Disability Access Report

To accompany the Section 4.56 Modification Application

Seniors Housing

1955 Pittwater Road Bayview NSW

Figure 1 - Screenshot of S4.56 Modifications to Unit 1 Lower Ground

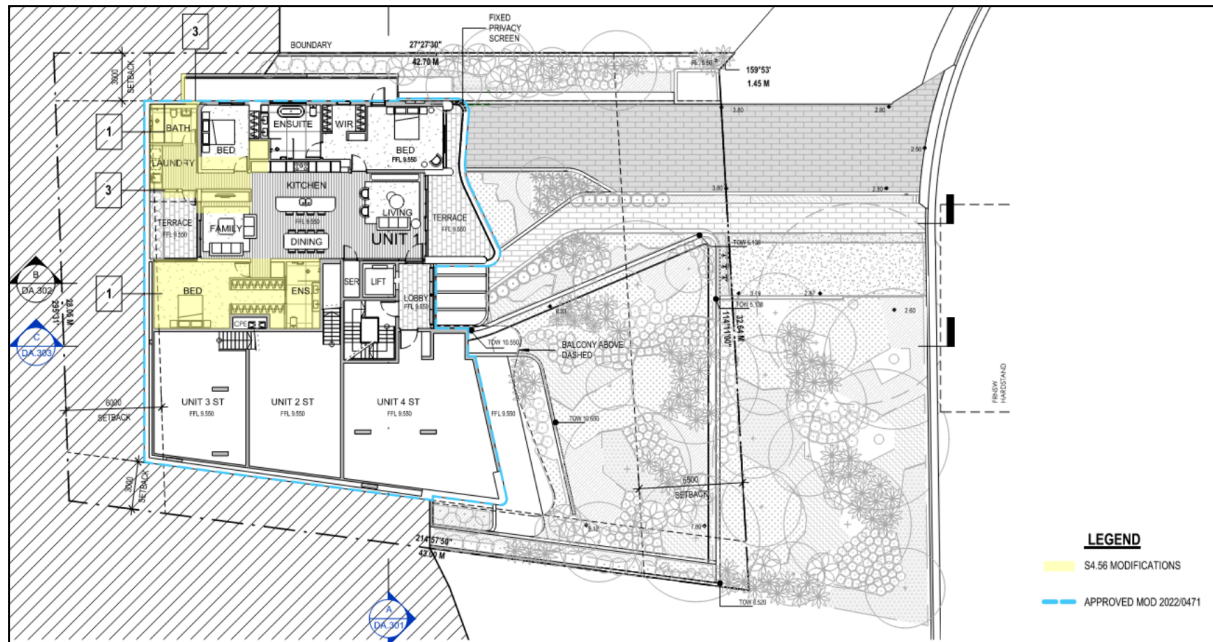
- **Unit 1:** Layout re-configuration to improve amenity by relocating the Laundry area
- **Unit 4:** Relocation of the Laundry Room adjacent to the entry lift.

The proposed changes detailed in the S4.56 drawings for Units 1 and 4 have been designed to comply with the Schedule 3 requirements for access to the laundry area. Specifically:

57.	(a) a circulation space at door approaches that complies with AS 1428.1, and	Revised S4.56 drawings for Unit 1 and Unit 4 show compliance with AS1428.1 door circulation approaches. Complies

59.	(c) a clear space in front of appliances of at least 1,300 millimetres, and	Complies for all of the units. S4.56 drawings indicate that 1300mm clearance is provided to laundry spaces within Unit 1 and Unit 4.
